Addendum #1

RE: REQUEST FOR TENDER #2024-137-P01947
Hess Street Elementary School – Renovation Project

Addendum No. 1

PROJECT:	HWDSB Hess Elementary School	DATE:	April 24 th , 2024
PROJECT #:	23035	FROM:	Binayak Raj Maurya
TO:	NGA Architects	ATTENTION:	Ivana Paukovic

SHEET NO.	DRAWN BY	CHECKED BY
M 0.03	VA	BM
PROJECT NO.	23035	SCALE
AS NOTED

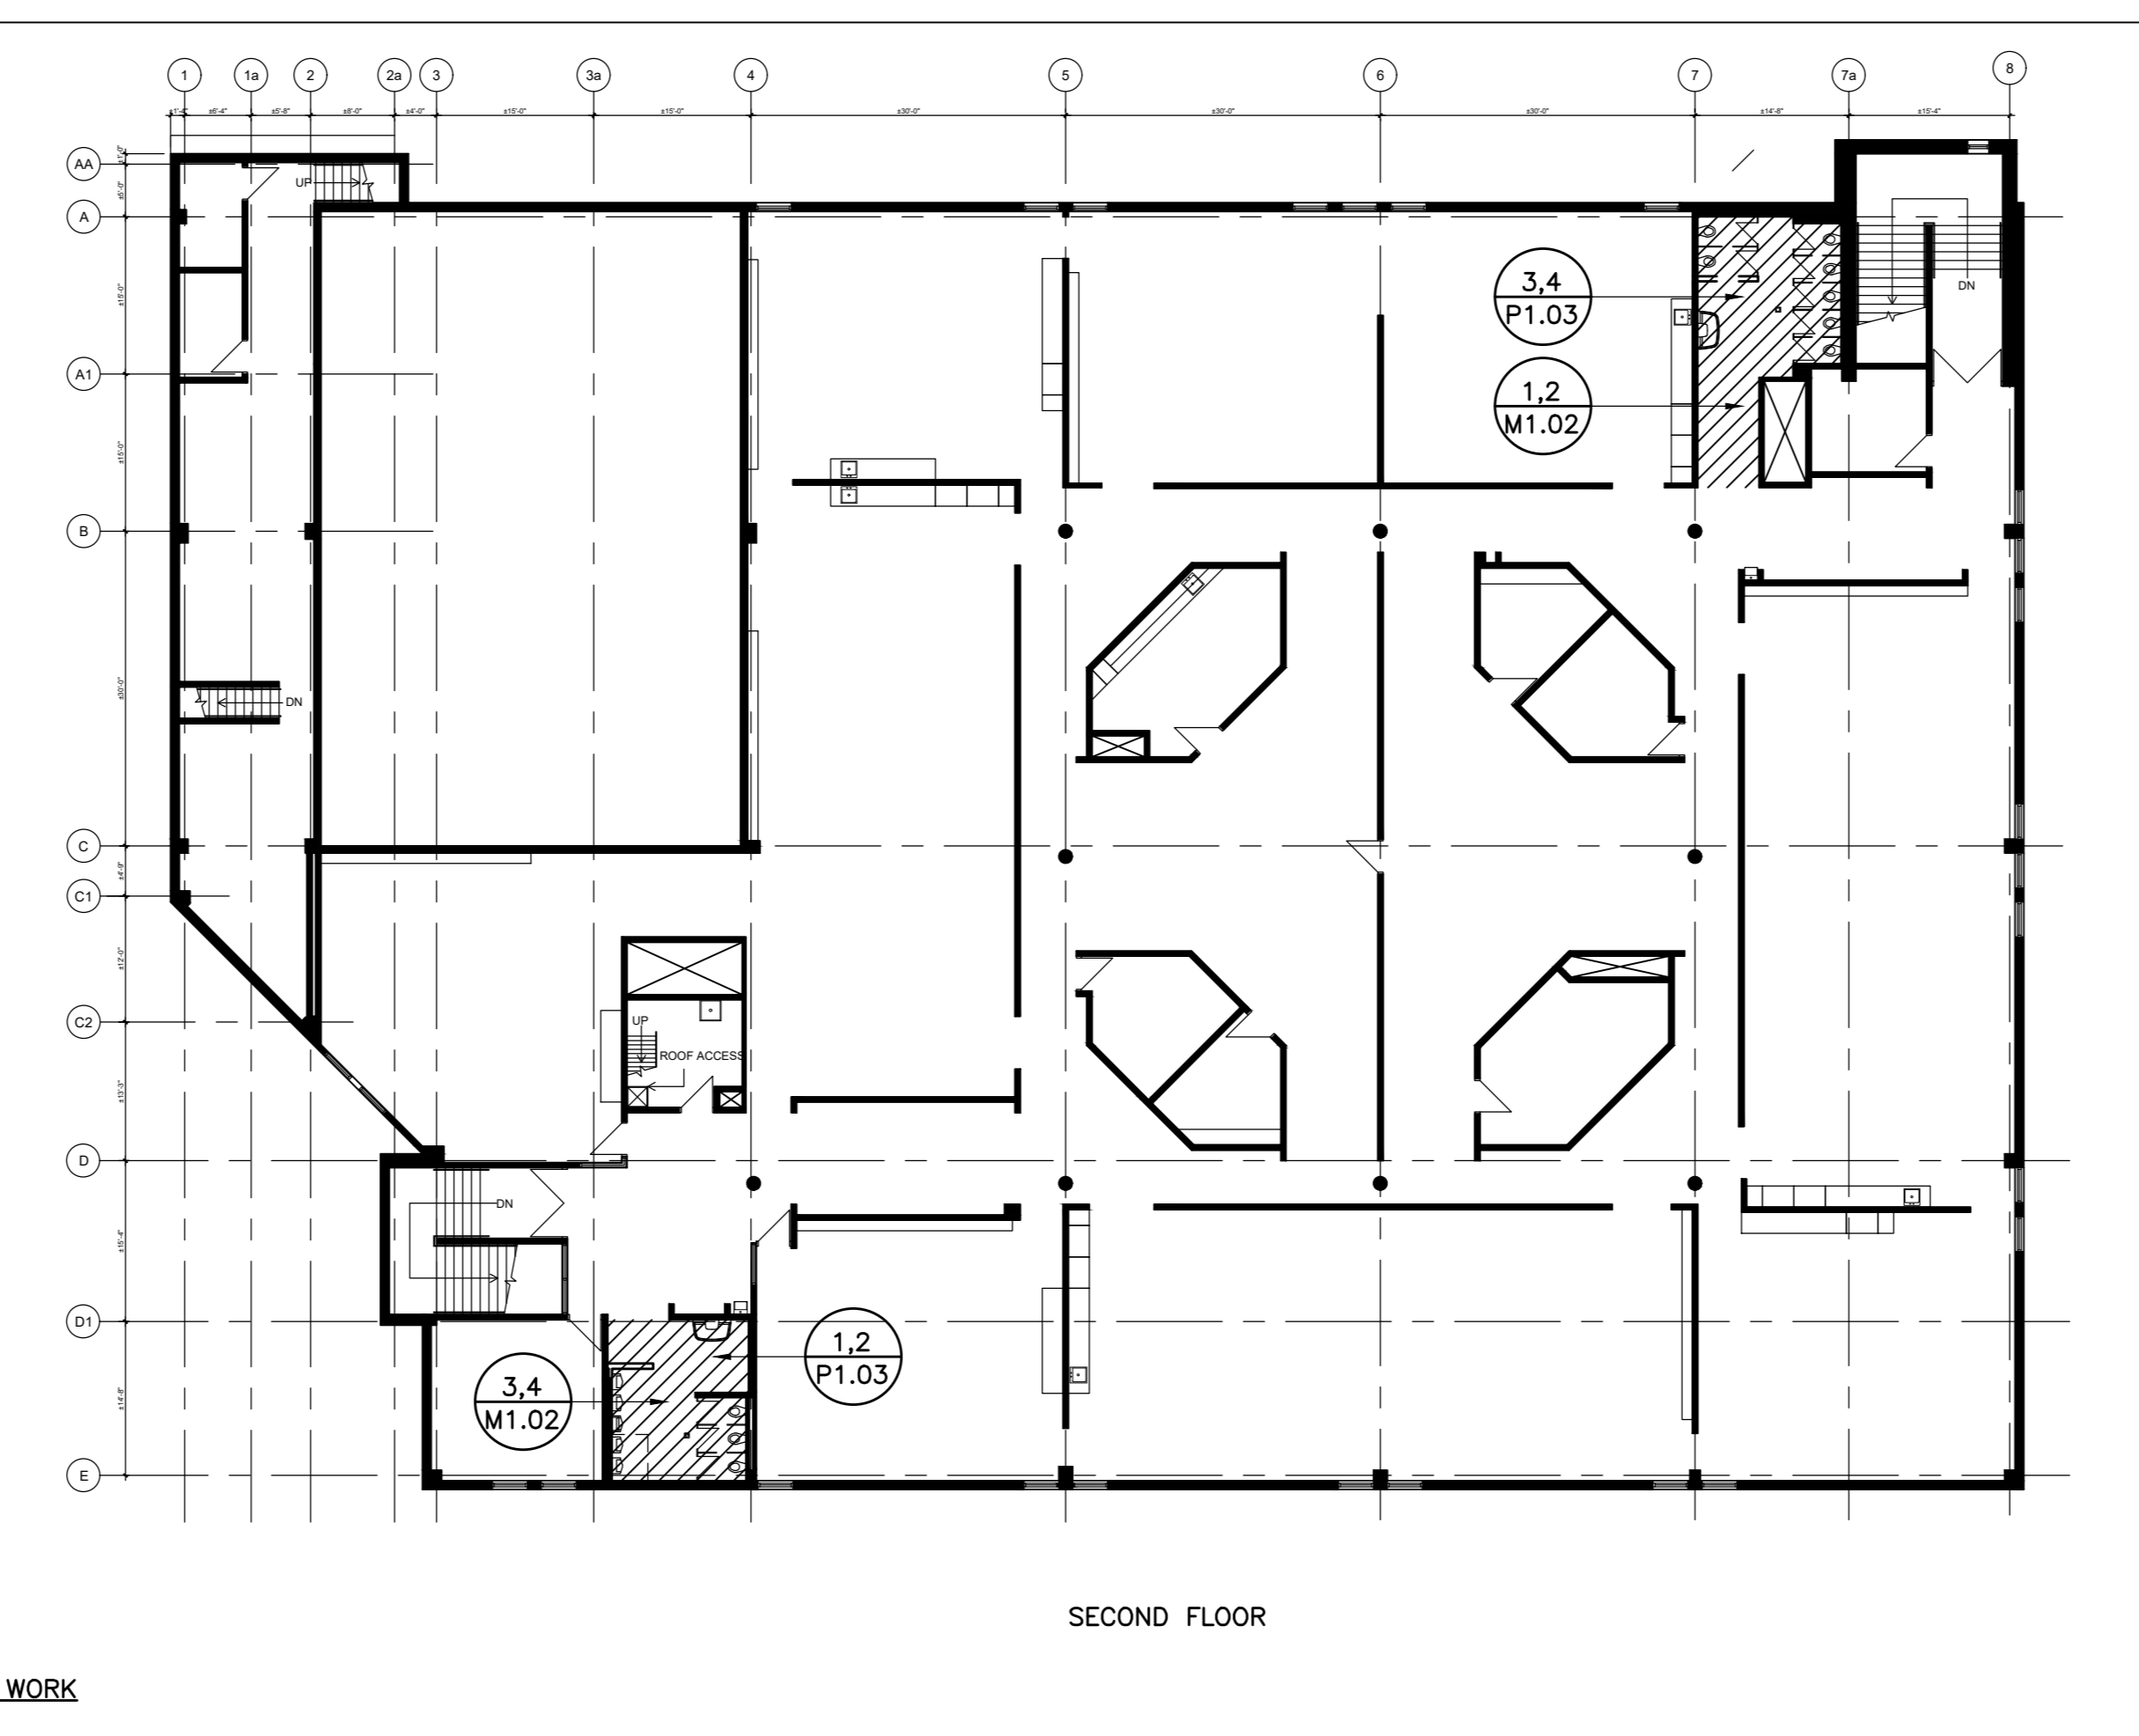
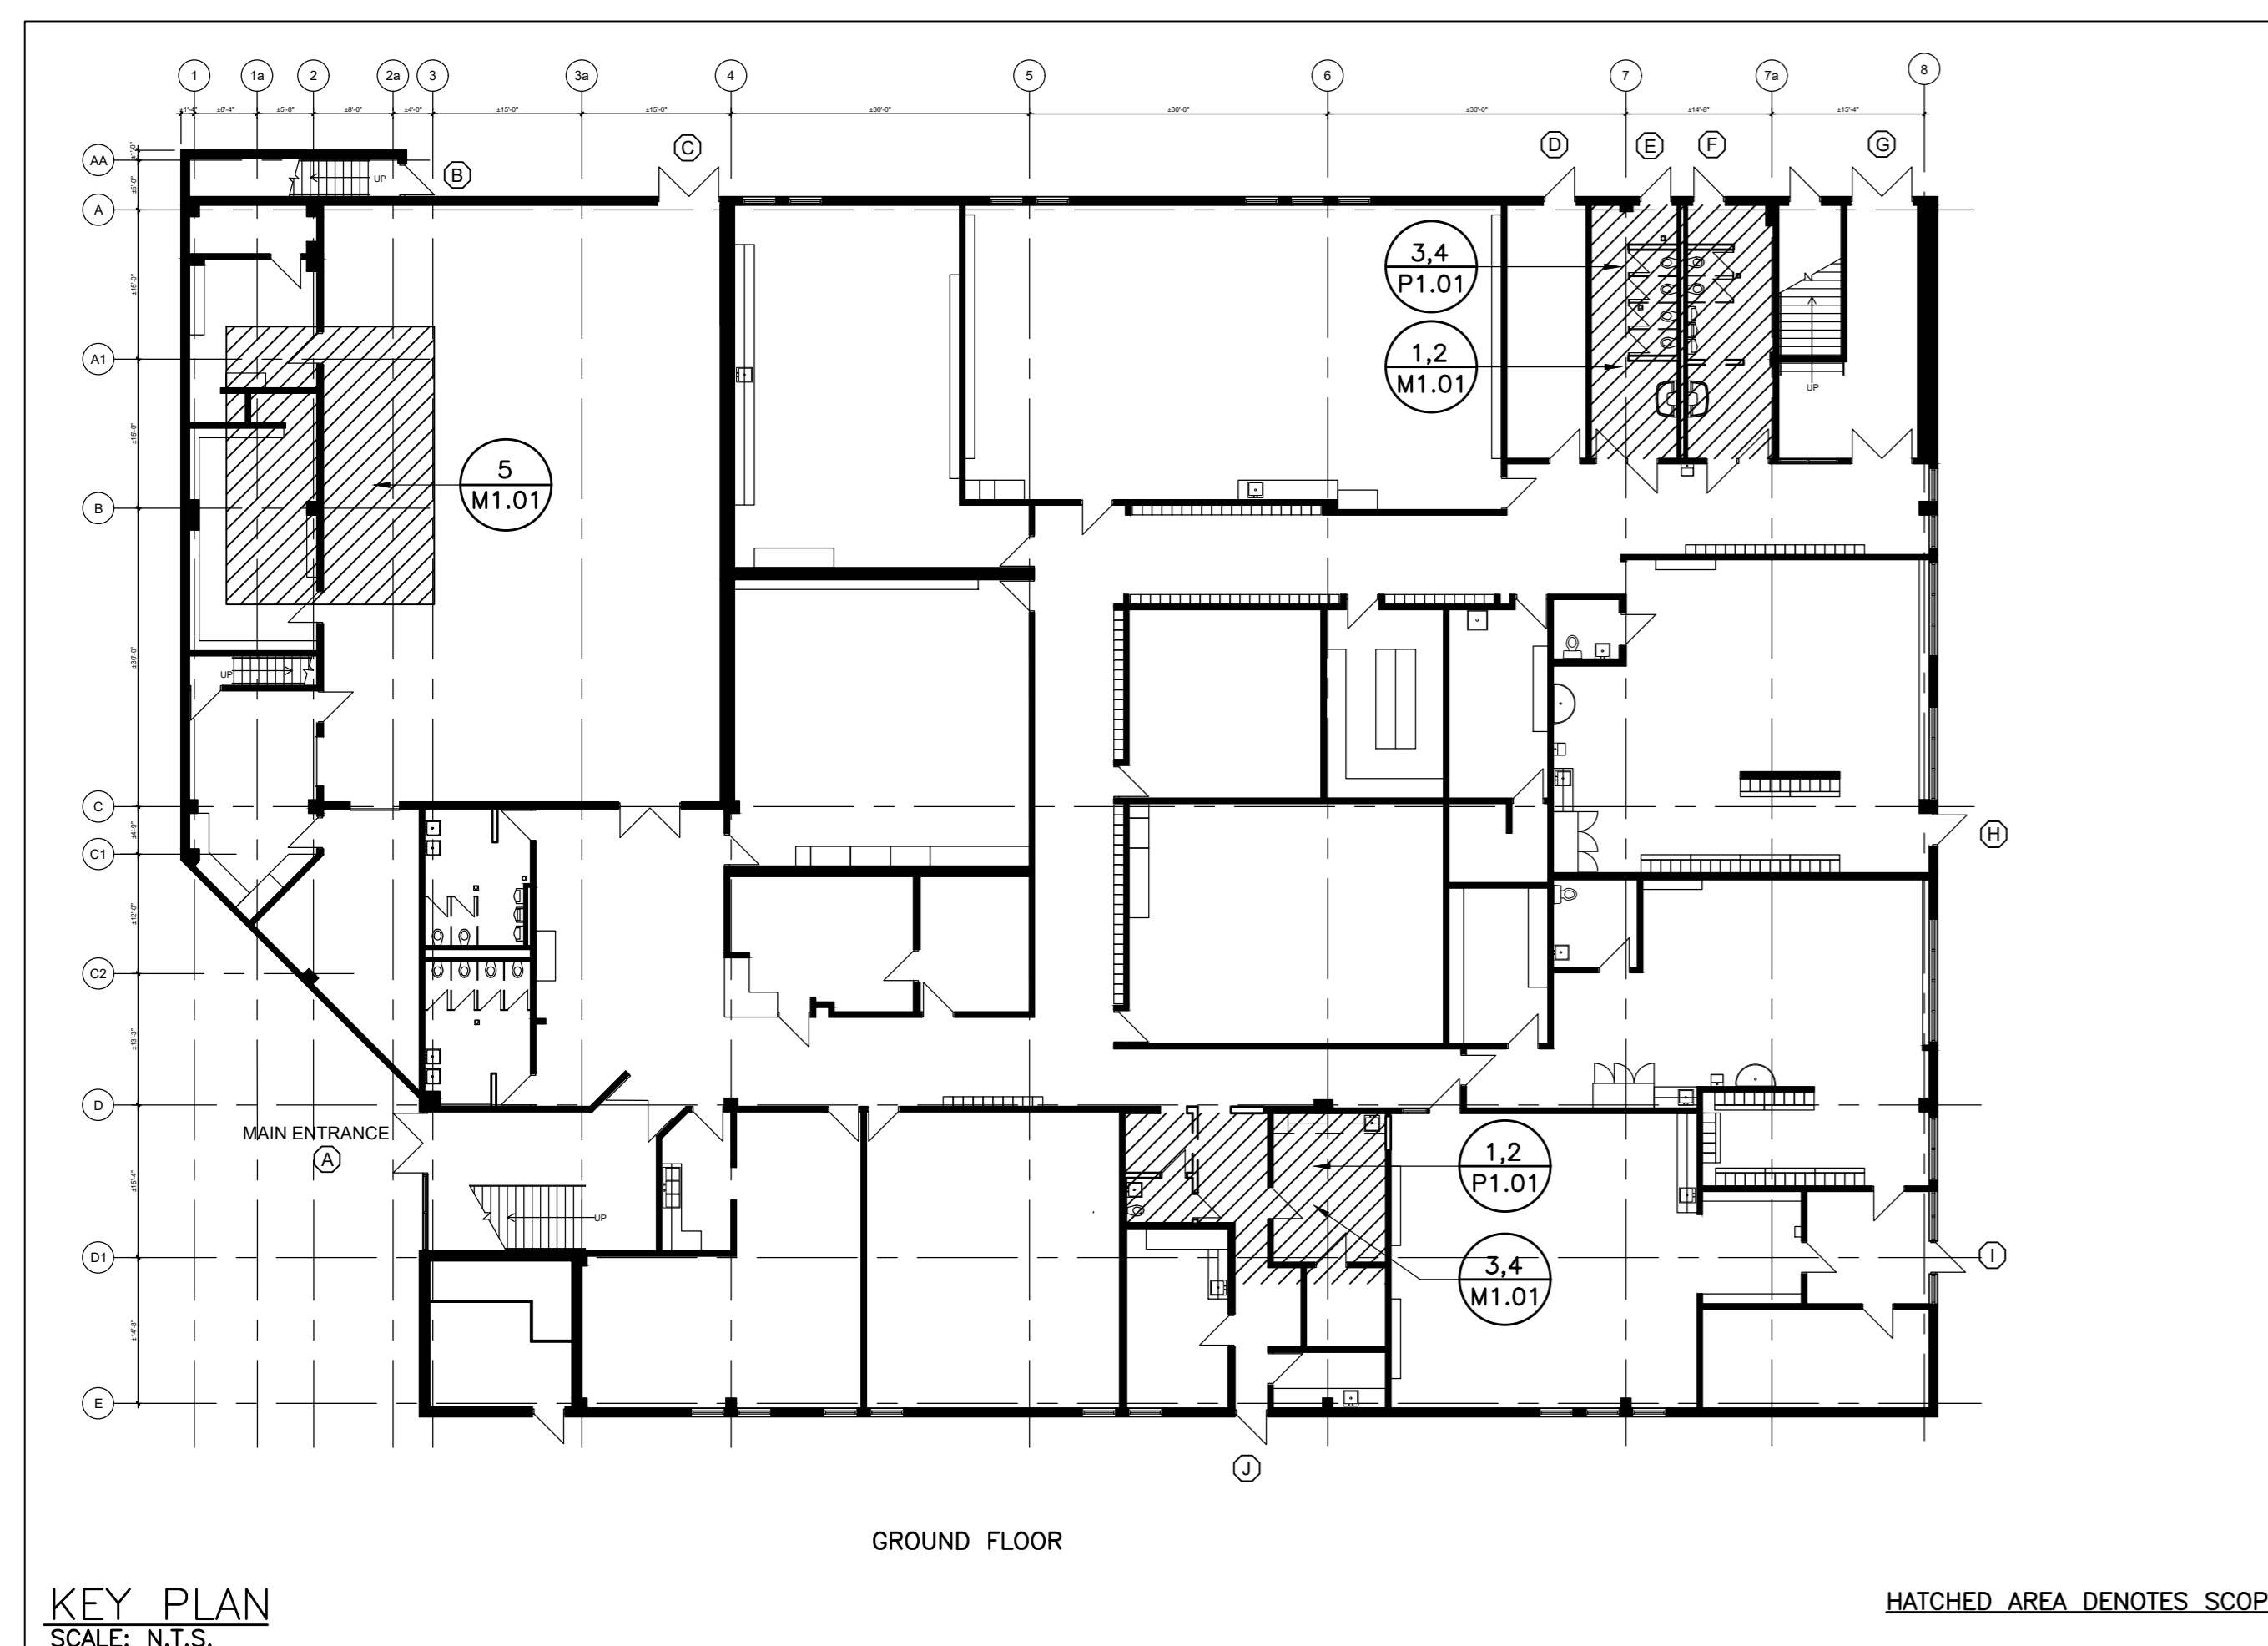
- 3) **Question:** The schedule shows H-1 and H-2. Where is H-2 located?

1.1 Refer to Mechanical Drawing M 0.03 Rev. C

- Tag “H – 2” has been removed in the Hydronic Wall Fin Heaters Schedule.

Answer: H-2 has been deleted since not required. Refer to attached Addendum No. 1 by CK Engineering Inc dated April 24, 2024.
